**WARRANTY
BULLETIN**

Wb97-32

DATE: December 1997	SECTION: 06
SUBJECT: A/C MODULE BY-PASS CIRCUIT

INSIDE OF L.H. REAR ELECTRIC COMPARTMENT

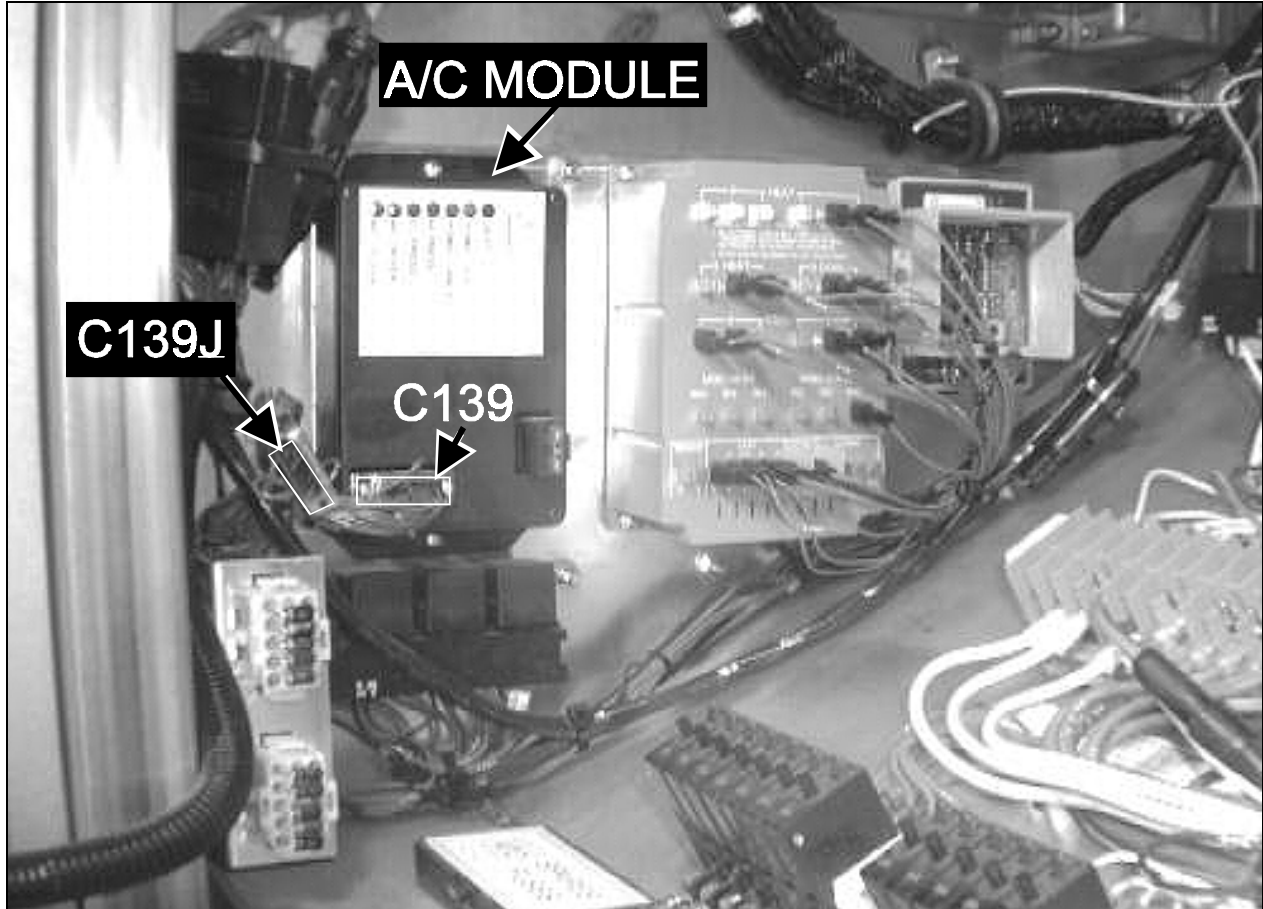
1. Open L.H. rear electric compartment door.
2. Locate on the L.H. wall, the connector C139 connected to A/C module (refer to figure), trace wiring harness of this connector up to the identification of connector assembly C139J. Remove cable tie retaining connector assembly C139J to wiring harness. Discard connector assembly then using a cable tie, fasten in its place the new connector assembly C139J (#064548).

Note: Connecting connector assembly C139J will be necessary only if you wish to by-pass the A/C module.
